MEMO

TO Eric A. Gustafson *GAJ 3/16/17*
FROM Harry C. Wise, P.G. *HCW*
DATE March 16, 2017
RE PGE – Indiana County Yanity Well #1025
Geological Review
EPA UIC Application Documents

Figure 1. Alleghanian folds near well site. Well surrounded by quarter-mile and one-mile buffers.

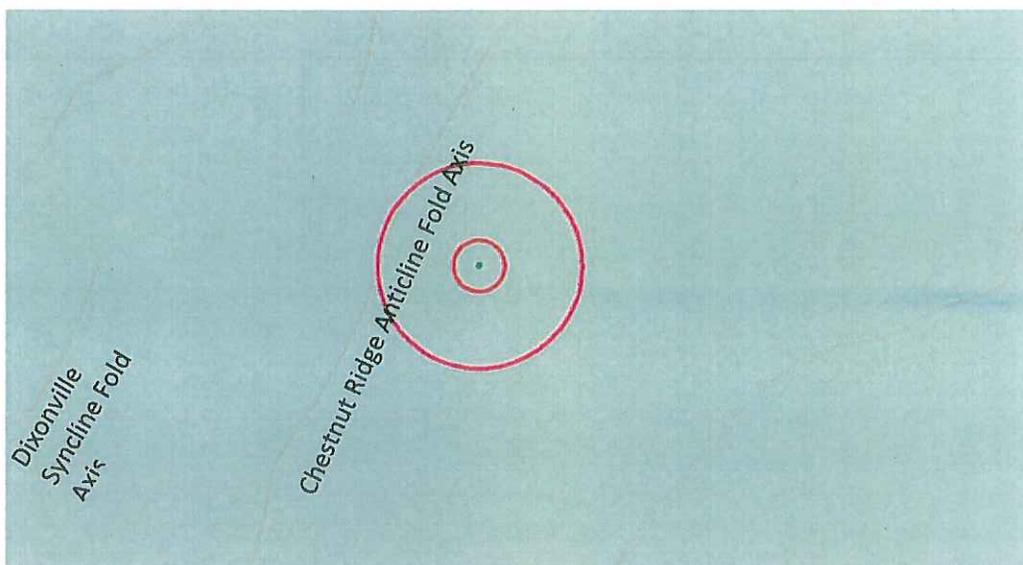
The Department reviewed Alleghanian structures to confirm the presence of a nearby anticline – the Chestnut Ridge Anticline is located along the northwestern edge of the mile-radius area of review (Figure 1). To the north of the site, the Chestnut Ridge Anticline merges with the Grapeville – Kinter Hill Anticline (also known as the Jacksonville Anticline) (Skema et al, 2008, Pennsylvania Department of Conservation and Natural Resource (DCNR) Open File Report OFMR 08-01.0). The merging of the anticlinal forms structurally pinches out the Dixonville Syncline west of the site. This structural complexity is consistent with PGE's discussion

Figure 2. Conventional (green) and unconventional (orange) wells with the quarter-mile and one-mile buffers depicted.

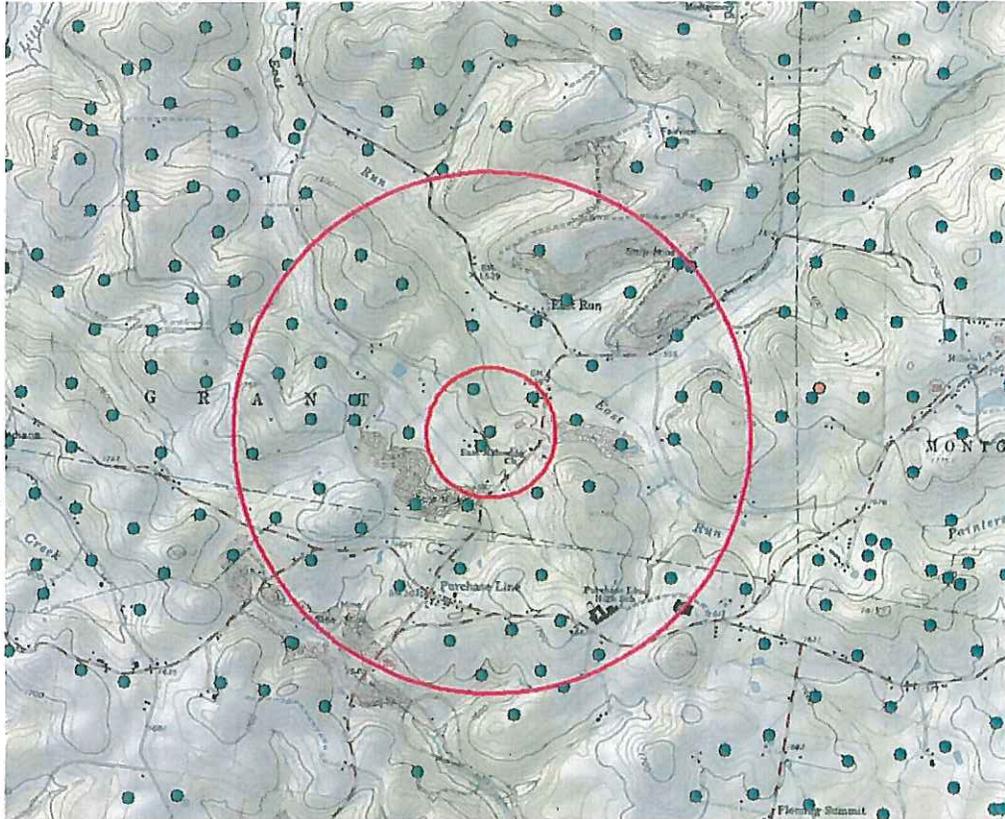
The Department's review of deep operating wells within quarter- and one-mile radial distances confirmed the information provided by PGE in the application and Notice of Deficiency response. The only operating wells that penetrate the produced horizon are PGE owned and operated wells. These include API# 063-32044, located 0.54 miles west-northwest of the site; API# 063-33809, located 0.71 miles north-northeast of the site; and API# 063-31663, located 0.96 miles northeast of the site. The wells are drilled to total depths of 7,788 feet, 7,794 feet and 7,780 feet, respectively (Figure 2).

One proposed Marcellus well is mapped within the mile-radius area of review along the eastern portion of site. This well is categorized as “proposed but never materialized” (API # 063-36091, by OGO 38602 – MDS Energy LTD) (Figure 2). The Department has field confirmed that this well was proposed but never drilled.

Figure 3. Historical well information with the quarter- and one-mile radius area of review.

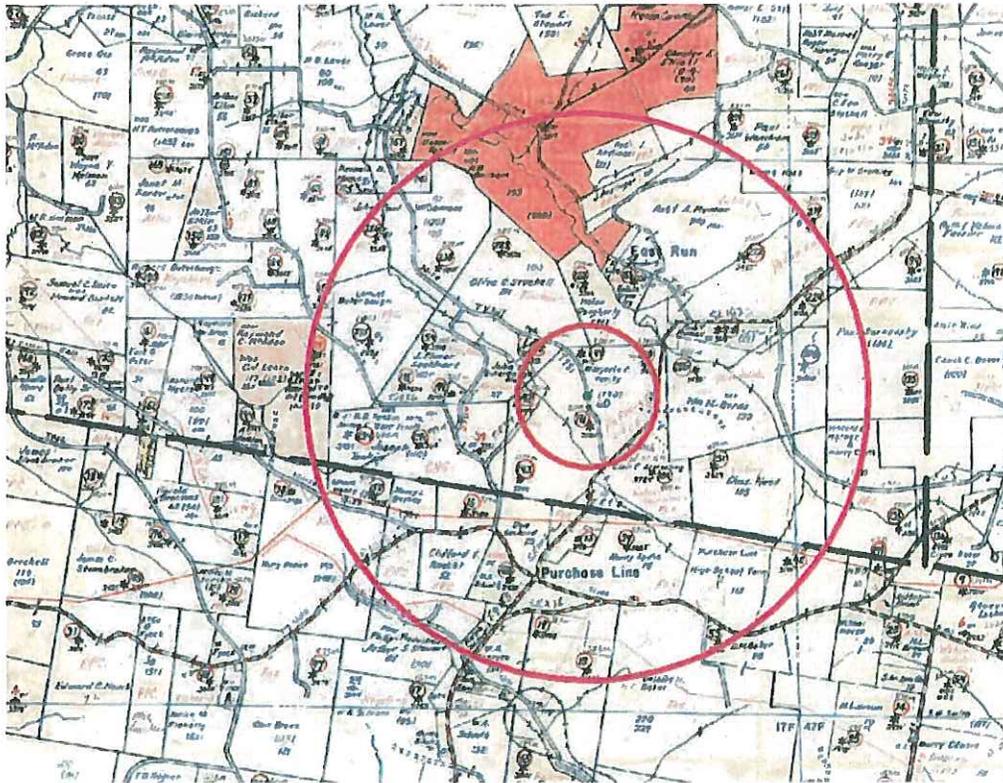
Historic and other well sites were reviewed. No wells exceeding a depth of 3,800 feet below existing site grades are located in the quarter- and one-mile radial distances around the proposed injection site. There are three wells located within the mile-radius buffer that PGE listed as proposed, but the Department’s eFACTS system lists as active. The API numbers of these wells are 063-36066, 063-36067 and 063-36068 (listed to OGO 38602 – MDS Energy LTD). The Department has field confirmed that these wells were proposed but never drilled (Figures 2 and 3).

Figure 4. Faults located near the proposed well site.

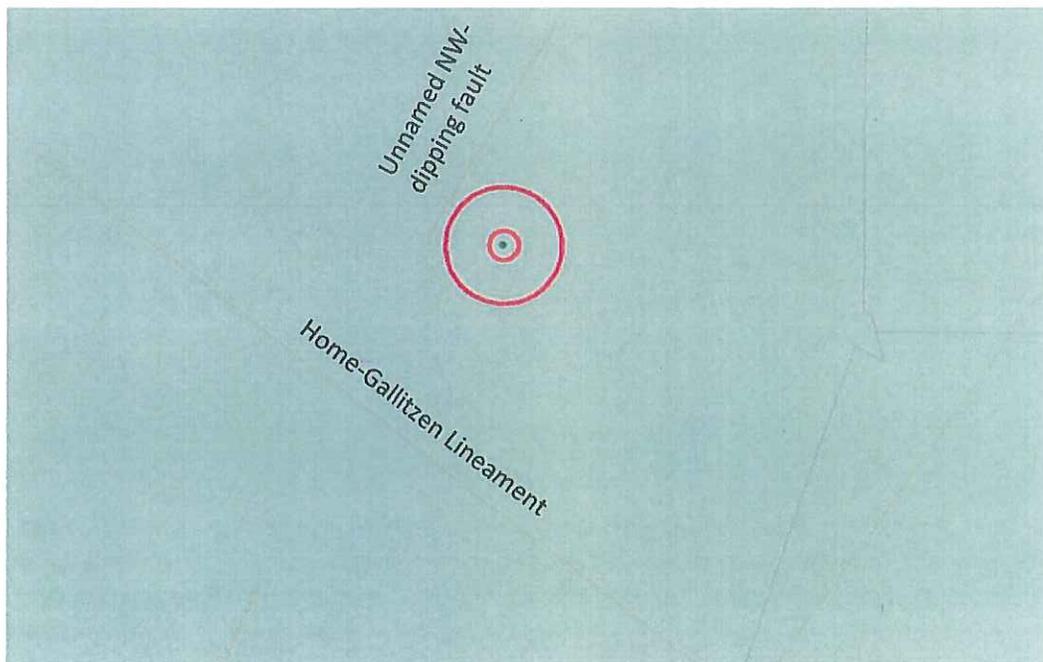
The Department's review indicates there are no mapped faults or structural fronts within the quarter- and one-mile radius area of review (Figure 4). This is consistent with EPA's review of the PGE application. The nearest fault is identified as an "unnamed fault" dipping to the northwest and located just northwest of the one-mile area of review. The Home-Gallitzin Lineament is located 3.68 miles southwest of the site. The faulting to the northwest appears to be coincidental with the regional folding structures classified as an anticlinal axis. Faulting is often noted in association with structural deformation features such as the anticline/syncline pairs common throughout the Appalachian fold belt/plateau of Pennsylvania. While these faults were active during the geologic history of the area, they are now considered "inactive" due to the changes in the geologic stress fields that are attributed to their formation.

Figure 5. Seismic activity map showing 3-mile buffers around Magnitude 2 or greater earthquakes.

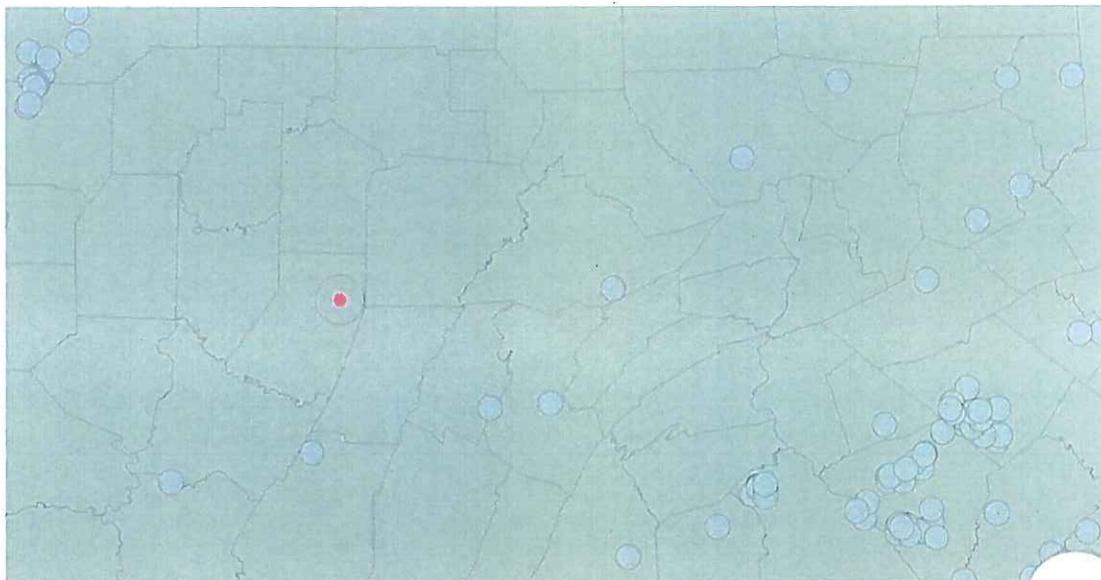
The Department's review indicates there are no historical seismic events within the quarter- and one-mile radius area of review (Figure 5). There are no earthquakes of magnitude two (2M) or greater within Indiana County.

Figure 6. Depth to Precambrian crystalline basement rock. UIC well site (pink circle).

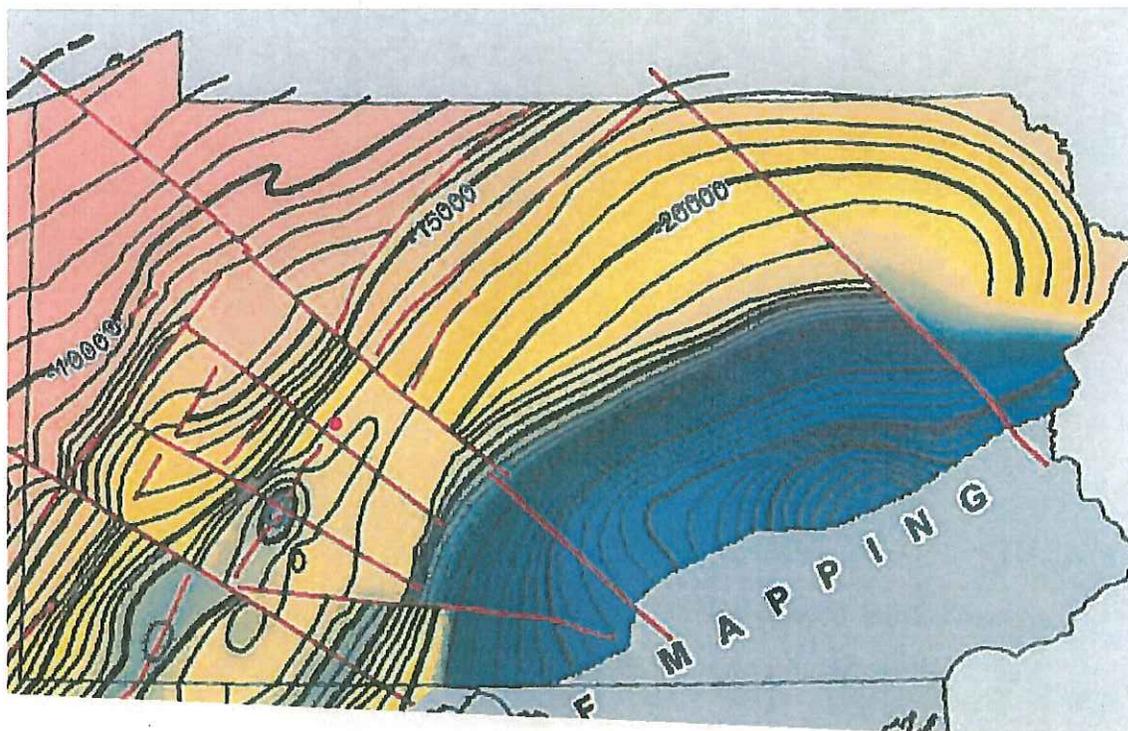
In EPA's Responsiveness Summary for Public Comments, Question 10 asks "What is the probability of the proposed Yanity Well #1025 injection well causing earthquakes like the ones in Braxton, WV, Youngtown, Ohio and other states?" In this report, EPA discusses how induced seismic events associated with injection wells in Ohio were created by disposal in Precambrian basement rock. These rocks are often cross-cut by blind faults or are crystalline in nature. Additional studies by the State of Oklahoma (<http://earthquakes.ok.gov/>) and within the geologic community appear to corroborate the belief that injecting fluid into brittle, crystalline basement rock can induce seismicity. In PGE's application, it is noted that geophysical investigations estimate the Precambrian basement rock is located approximately 10,000 feet below the injection zone. The Department's review of maps showing the basement rock (depth of approximately 17,000 feet) and the injection zone (depth of 7,532 to 7,622 feet) for this well indicate a separation distance of approximately 9,300 to 9,400 feet (Figure 6).

Figure 8. Map showing surface and underground mining activities in the area. Quarter-mile and one-mile buffers depicted.

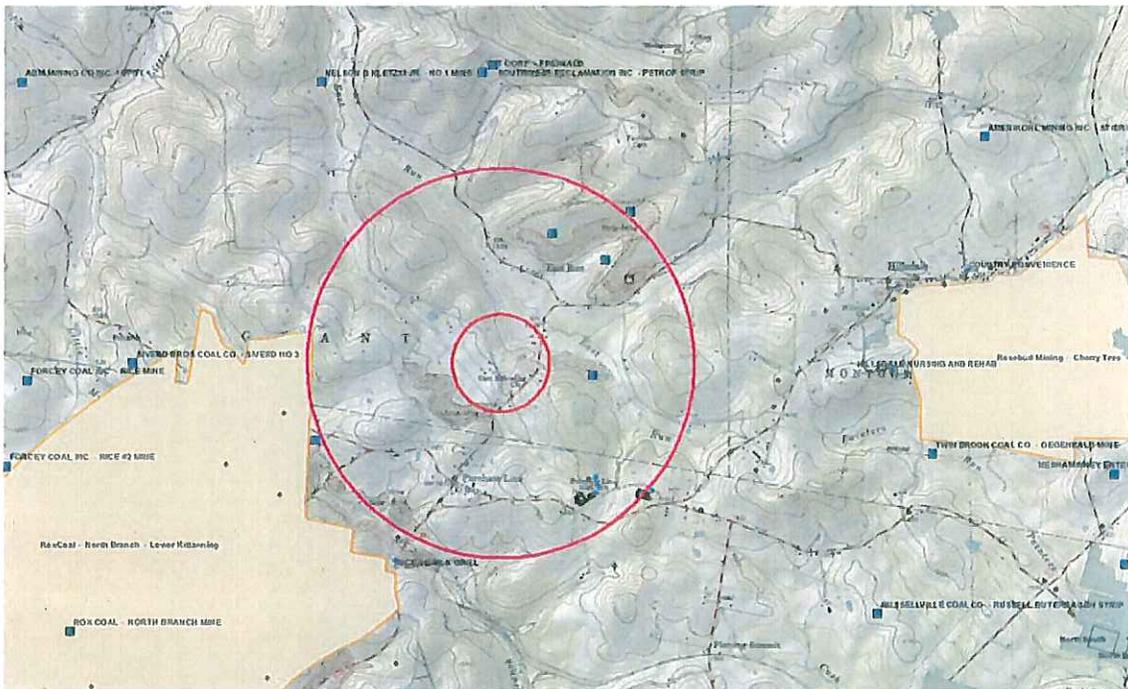
The Department's review indicates there is surface mining within the quarter- and one-mile radius area of review. However, there is no deep mining within the quarter-mile buffer. There is an active deep mining permit boundary that may encroach on the mile buffer in the future depending on resource development in the area (Figure 8). The mining that was identified appears to be consistent with PGE's application to EPA. There is no deep mining within the quarter-mile area of review, thus the injection well's integrity is not expected to be affected by contact with mine waters or structural deformation. In addition, the distance of this well from any existing or planned mines is great enough that there is no anticipated potential for communication of injected fluids with current, former, or planned mining activities.

Figure 9. Map showing public water supply wells. Quarter-mile and one-mile buffers depicted.

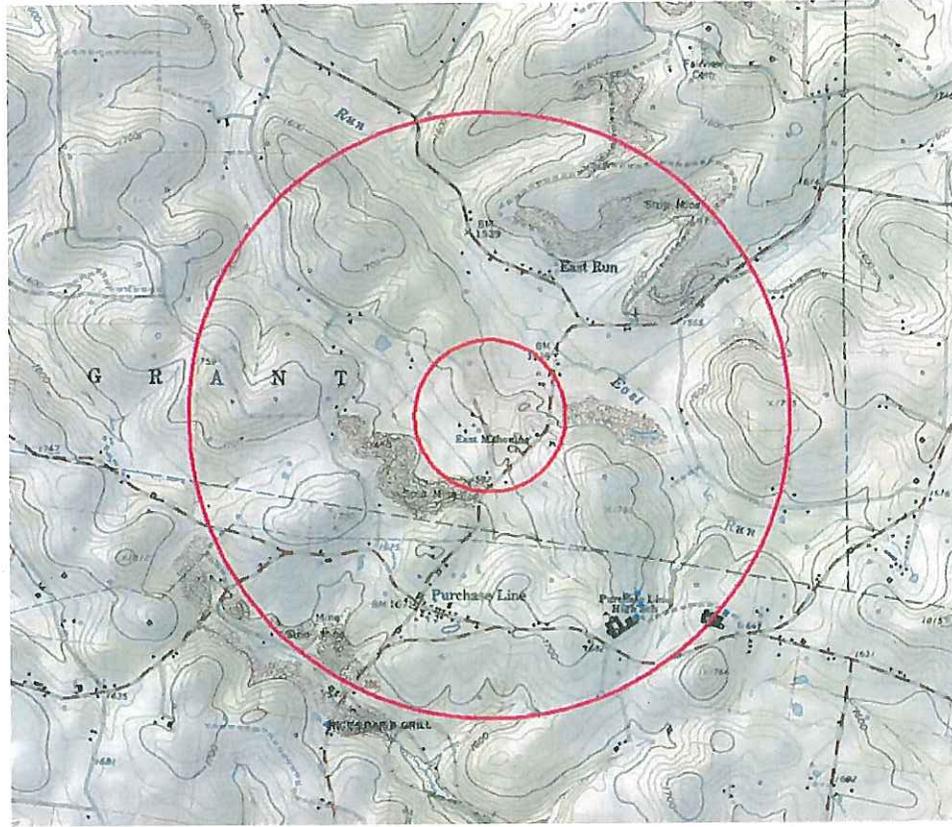
The Department's review indicates there are active municipal water wells associated with Purchase Line School District within the 1-mile radius of review. These wells are located southeast of the site (Figure 9). Since the casing and cementing requirements of 25 Pa. Code Chapter 78, Subsection D are satisfied, there is no expected risk to these wells provided injection well integrity is maintained. In PGE's application to EPA, 13 private water wells were identified within a quarter-mile radius area of review and PGE documented the deepest USDW well to penetrate to a depth of 520 feet below existing site grades. The Department concurs with PGE's statement that the well construction details at the proposed UIC well (fully cemented surface casing at 569 feet and fully cemented intermediate casing at 1,539 feet) is adequate to protect groundwater in the area of the proposed injection well. The EPA did not raise any concern with the analysis during their review.
